These amendments relate to both the increase in the limiting nuclear enthalpy hot channel factor (F_{AH}^N) for Surry Units Nos. 1 and 2 and to the replacement of 81 of 157 fuel assemblies in the reactor core of Surry Unit No. 2 constituting refueling of the core for third cycle operation.

AMENDMENT TO FACILITY OPERATING LICENSE

Amendment No. 20
License No. DPR-32

ATTACHMENT TO LICENSE AMENDMENT NO. 20

FIGURE 3.12-1B CONTROL BANK INSERTION LIMITS FOR NORMAL 3 LOOP OPERATION - UNIT 2

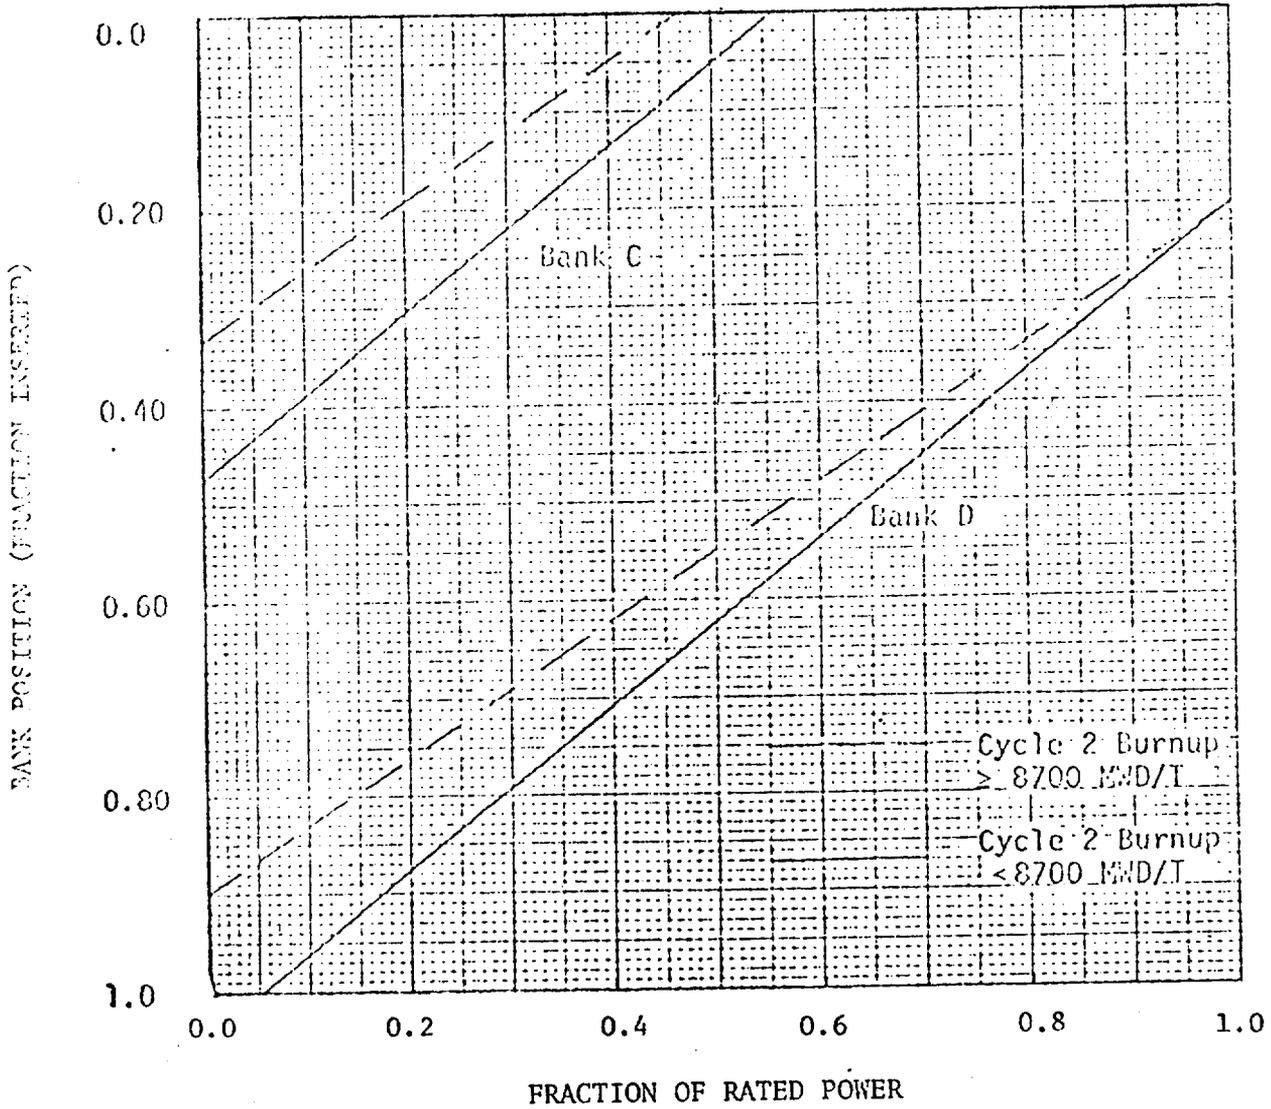
The licensee has proposed for Unit No. 2 only (Reference 1) a Technical Specification change on the rod insertion limits for Cycle 3 operation. Those limits, as discussed in this report, are acceptable.
